WEEKS MARINE INC.**WMI Job No. 2010-0148****REQUEST FOR INFORMATION (RFI) NO. 002****CONTRACT NO. B000964.001**

ARCADIS RFI number: 003,
Weeks RFI No 002

SECTIONS
SHEET 2 OF 3
STRUCTURAL

DWG. No.		REFERENCE DRAWINGS	
 WEEKS MARINE, INC. (908) 272-4010			
LOWER PASSAIC FENCE RESTORATION			
DRAWN BY: TGI		SCALE:	DWG. SIZE FORMAT:
CHECKED BY:		DATE: 08/31/12	11x17
APPROVED BY:		SHEET 1 OF 2	REF:
REV. #		DATE	BY

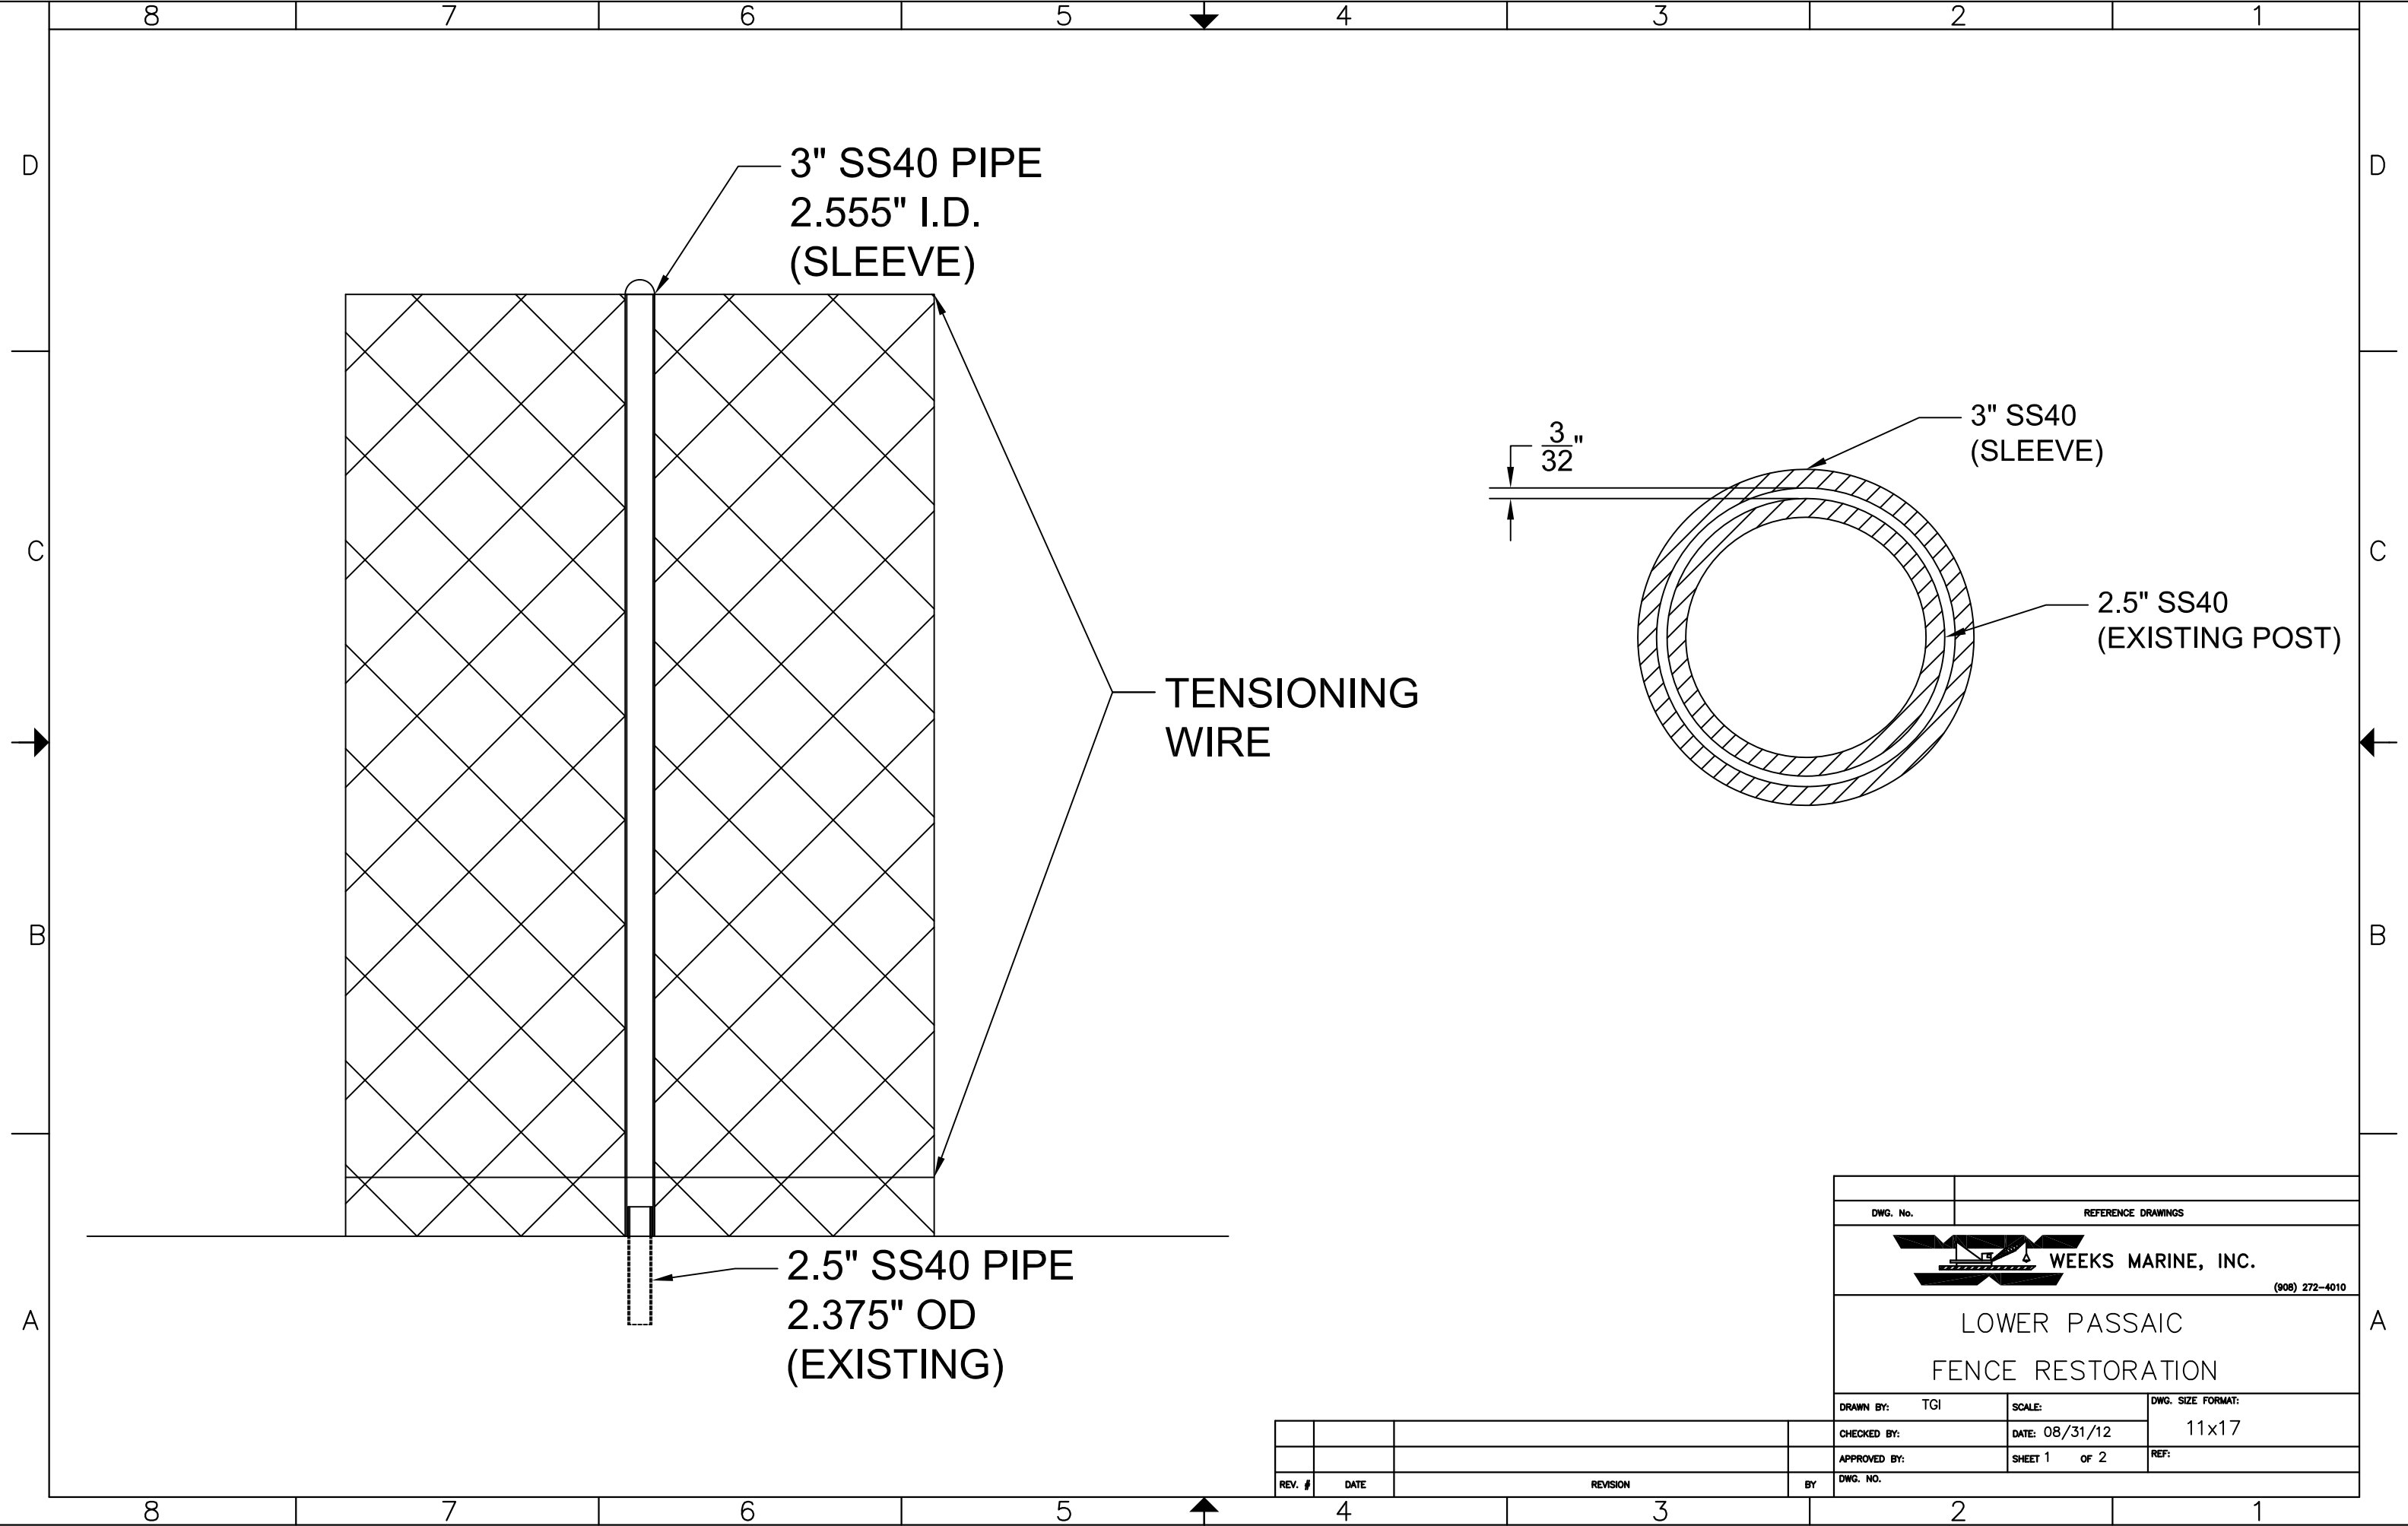
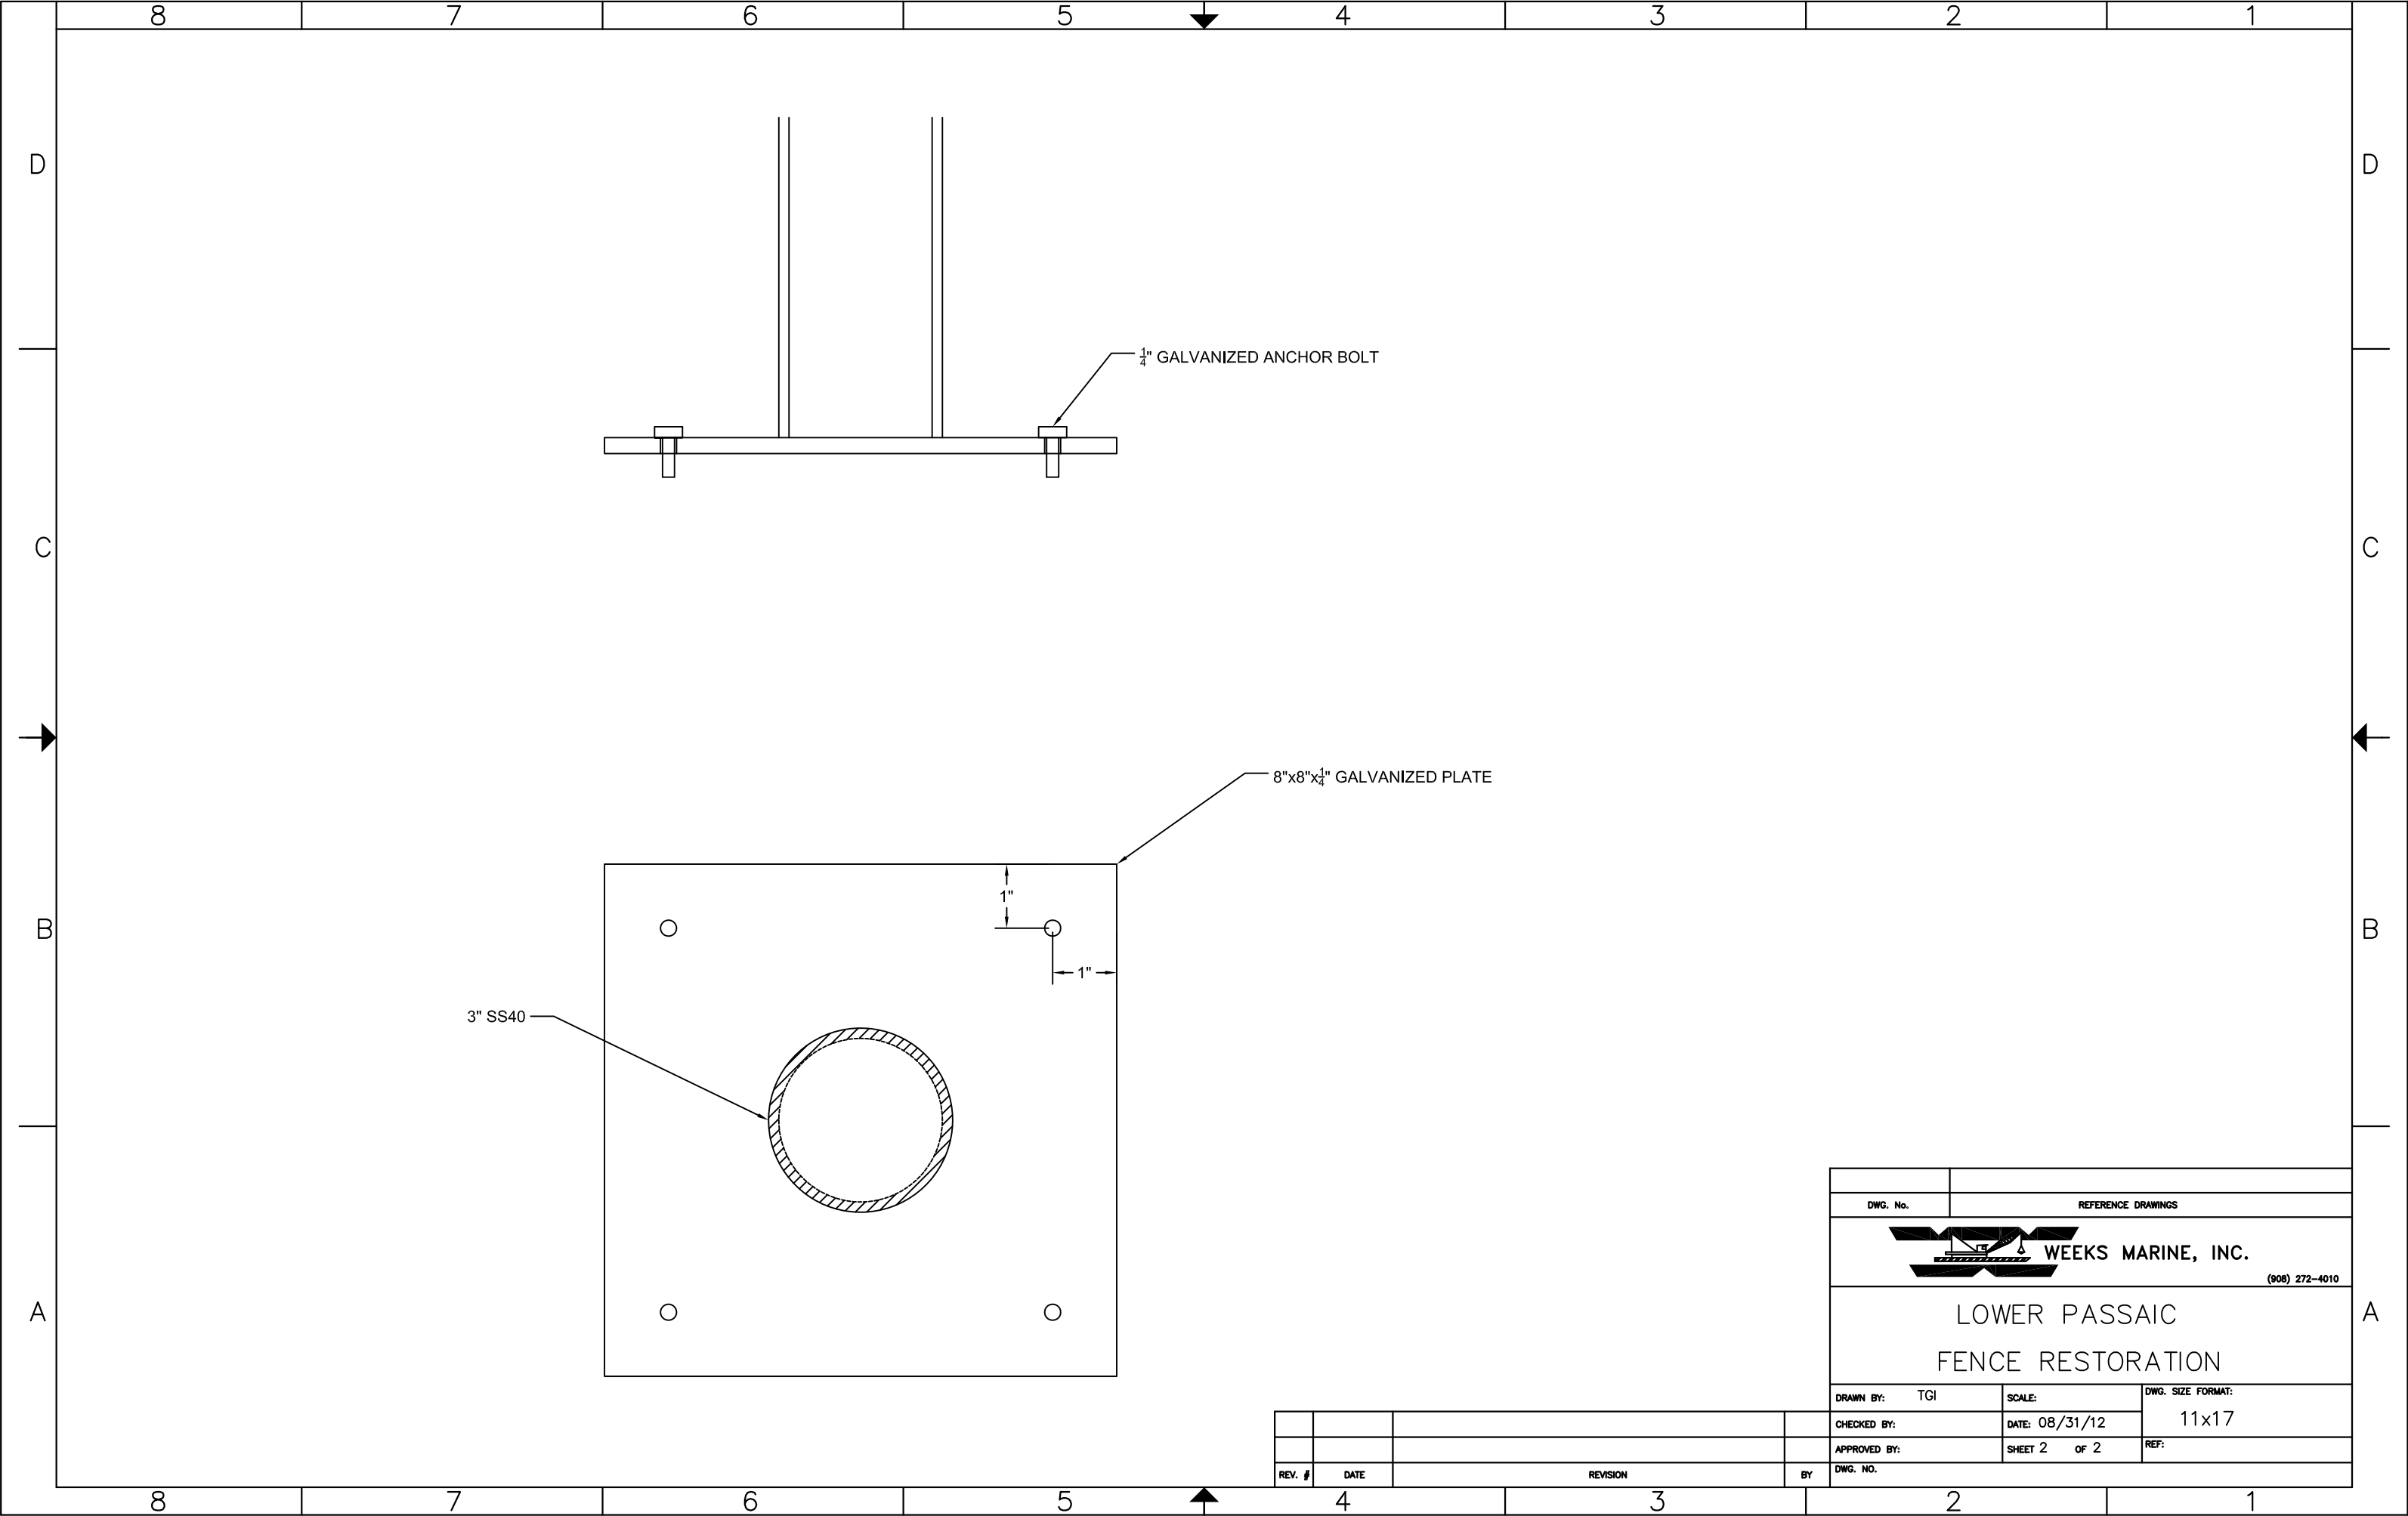
The re-installation of approximately 610' linear of existing eight foot high galvanized chain link fence will be performed as follow:

- New 3" fence posts will be sleeved over the existing 2" fence posts.
- At 2 locations a steel plate 8" x 8" will be anchored to hold the 3" fence posts.
- Tension wire will be installed at the top and the bottom, which will hold all the 3" post in place and straight.
